Interactive comment on “Climate impact on floods – changes of high-flows in Sweden for the past and future (1911–2100)” by B. Arheimer and G. Lindström

B. Arheimer and G. Lindström

Comments to J. Parajka (Referee) We are very happy to notice that the paper was appreciated and will address how to make further improvements based on the suggestions made by Dr Parajka. First, we chose not to put too much emphasize on specific rivers as we wanted to avoid noise and look for more general trends of climate change. However, we also recognize that there is information in our data material that may get lost by this approach, and as Dr. Parajka points out this is especially with regard to shift in flood regime or seasonality. We therefore suggest that we include a new Figure showing the shift in seasonality for some 15 rivers across Sweden, illustrating the

Fig. 1.

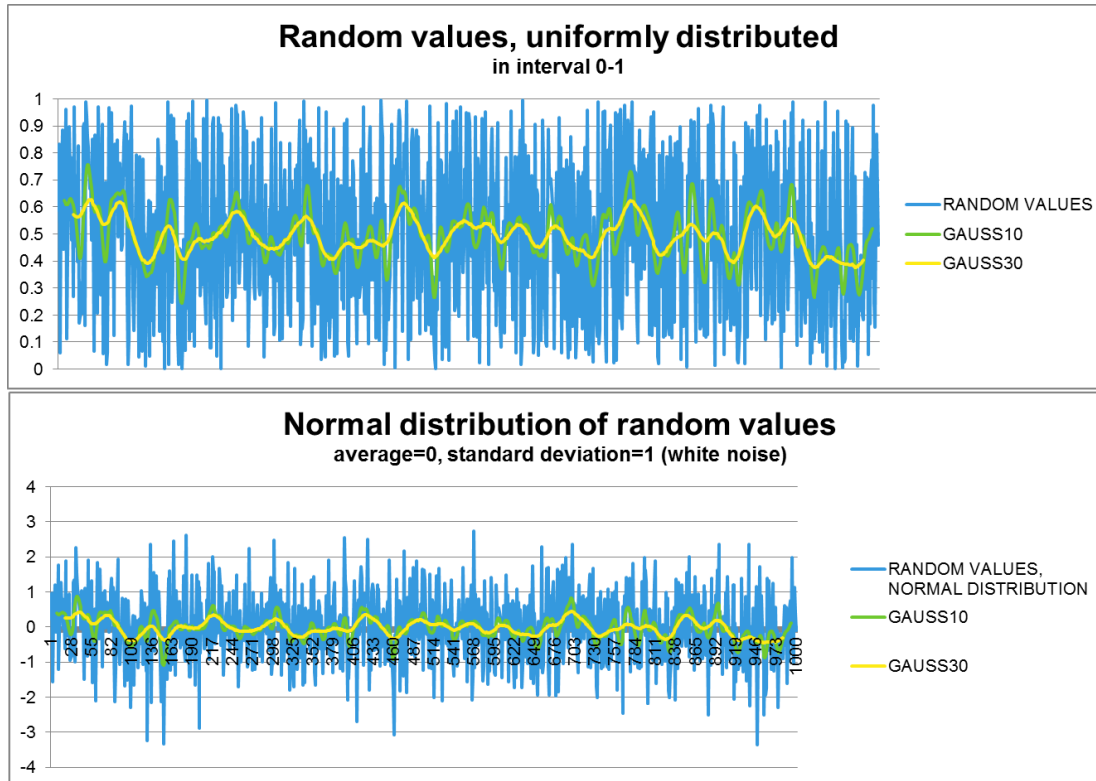
Regarding the filtering, we have used a Gauss filter to visualize trends without distraction from the noise caused by natural variability. However, as the Reviewer points out, the filter does not remove all noise and some oscillations remains also in a random dataset (see figure below). However, the filter does not introduce any new oscillations. The past differences between periods are real, and not artefacts introduced by the filtering (which is shown in the paper Figure 2, where annual values are also given to show the effects of the filter). For instance the 1970s was a dry period in practically all of Sweden, whereas the 1920s, 1980s and 1990s were mostly wet years, with a higher frequency of high autumn flows. The same periods stand out in other Nordic countries as well. A Gauss filtered signal, which is based on random values does not show trends (as for instance in the paper Figure 5) although it creates persistence (see below). The filtering is merely used for smoothing the signal and computing decadal averages, but without the disadvantages of an ordinary running average. The Gauss filter acts as a low-pass filter. It removes most of the year to year variation, and thus allows changes with a longer time scale, for instance decades, to be more visible. It might be interesting to note that the same pattern of more persistent periods of drier and wetter years as have occurred in the past (and which are not introduced as an artefact by filtering), seems to be preserved in the climate projections for the future. For climate projections, it is very important not to analyze specific years as the climate models do not have that predictability but only show general trends and fluctuations that may not be in phase with the observed climate. Therefore, we

chose not to show specific years from climate impact modelling but only the general tendencies, which are seen more clearly by the filtering. We suggest that we keep the Gauss filter when presenting our results to make the paper easier to read and more correct for climate interpretations. It is a very common way to present climate data over long time periods. We thank both reviewers for their time and recommendations to help us improving the paper!
